Well Name: SEINFELD FEDERAL UNIT MH	Well Location: T24S / R35E / SEC 34 / NWNW /	County or Parish/State:
Well Number: 221H	Type of Well: CONVENTIONAL GAS WELL	Allottee or Tribe Name:
Lease Number: NMNM138893	Unit or CA Name:	Unit or CA Number: NMNM141169X
US Well Number: 3002551156	Well Status: Approved Application for Permit to Drill	Operator: TAP ROCK OPERATING LLC

Sundry ID: 2725371

Type of Submission: Notice of Intent **Type of Action:** APD Change

Drilling Operations Plan
Seinfeld Federal Unit MH #221H
Tap Rock Operating, LLC
SHL 12' FNL & 810' FWL, Sec. 34
BHL 30' FNL & 660' FWL, Sec. 22
T. 24S., R. 35E Lea County, NM

WELL LOCATION AND ACREAGE DEDICATION PLAT

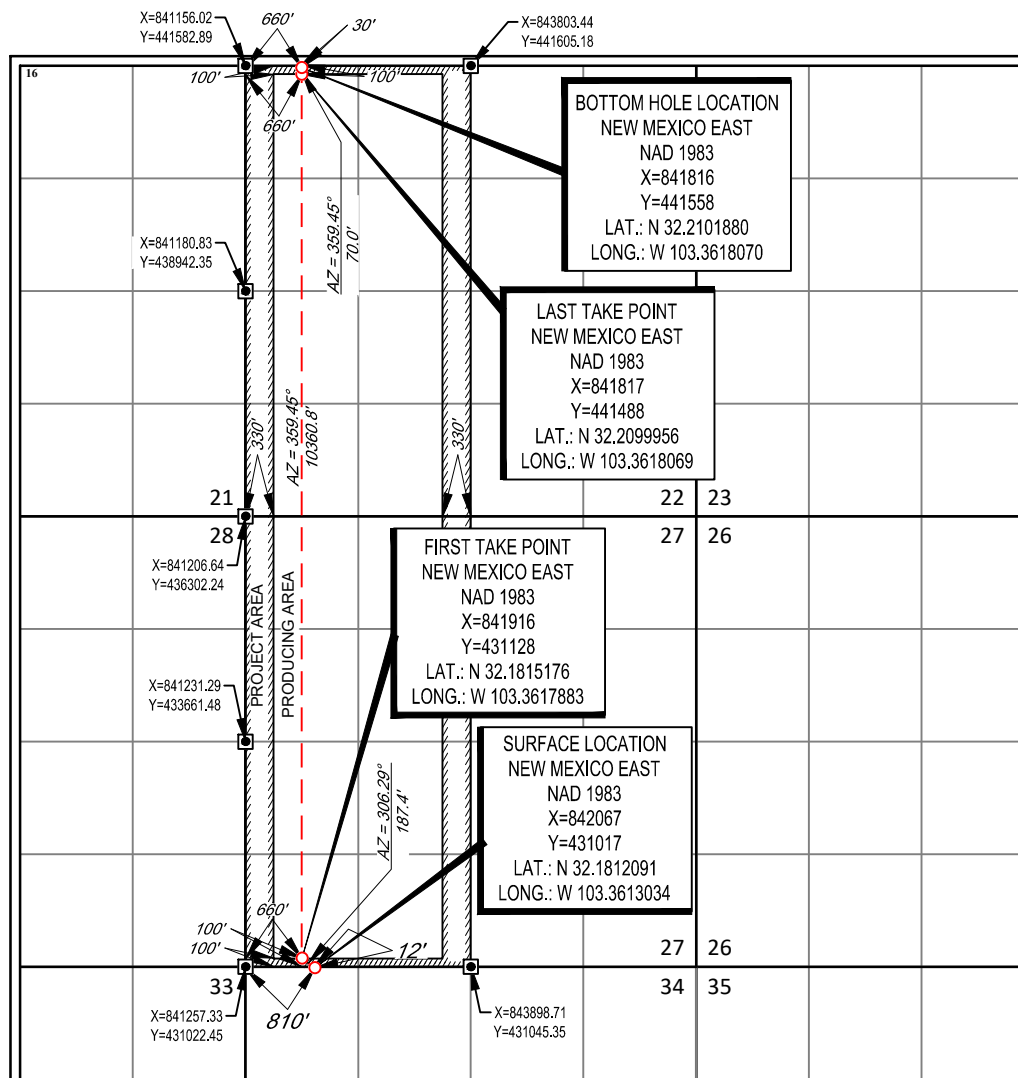
Procedure Description: For the referenced well, Tap Rock requests: 1. To change the referenced well name from Man Hands Fed Com 221H to: Seinfeld Federal Unit MH 221H. See attached updated C-102. 2. To change modify OH size and casing/cement design. See attached casing, cement, and mud tables.
